MINUTES
PLANNING COMMISSION MEETING
1300 NE Village Street
Fairview, OR 97024
Tuesday, September 8, 2015

b. Application 2015-52-Design & Natural Resource Review

Northbrook Village

Utility Plan

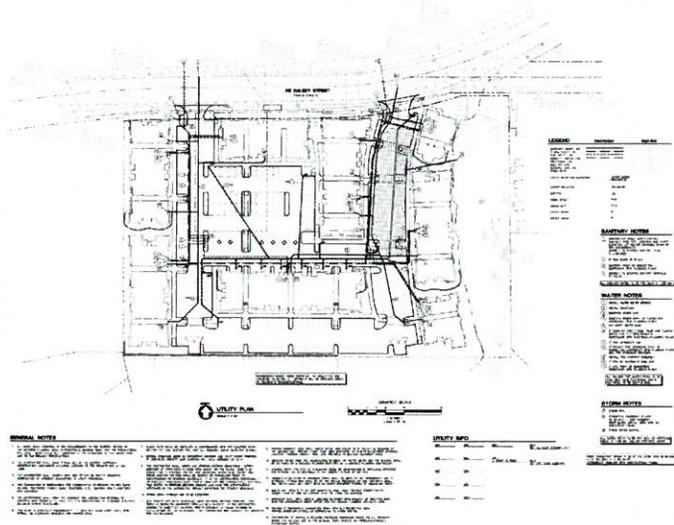
Commissioner Stonewall inquired how the development density compared to the density in the Village in relation to parking and where the stormwater treatment would be. Senior Planner Palmer replied she would have to calculate the density but believes it is similar. The development includes designated commercial and residential spaces. Storm water treatment will be below ground. There will be chambers to filter the water and release it at a slow discharge rate.

Mitigation Plan

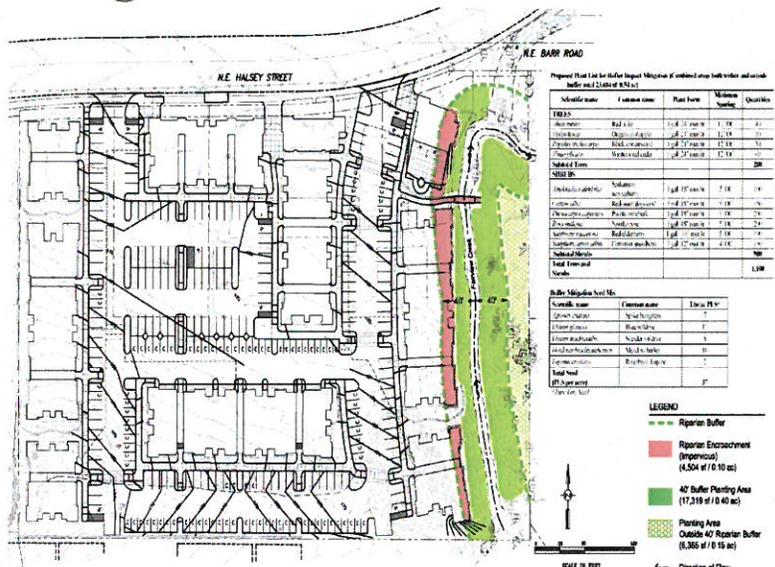
Ms. Dawn Greenwell, Fairview, OR commented on her concerns for protection of the riparian buffer. In her opinion buffer averaging does not provide enough mitigation for the run-off from a development. She challenged the Commission to require the applicant to redesign the development so it does not encroach into the buffer. She noted Fairview does not have the manpower for long term management of riparian buffer protection areas after the 5 year requirement has been met.

Mr. Lloyd remarked he appreciates Ms. Greenwell's concern for run off into the stream. The applicant hired an environmental consultant to create a mitigated buffer. They believe the net impact not only mitigated the buffer but increased its efficiency. They are confident there will be no harmful run off into the stream or degradation to the buffer.
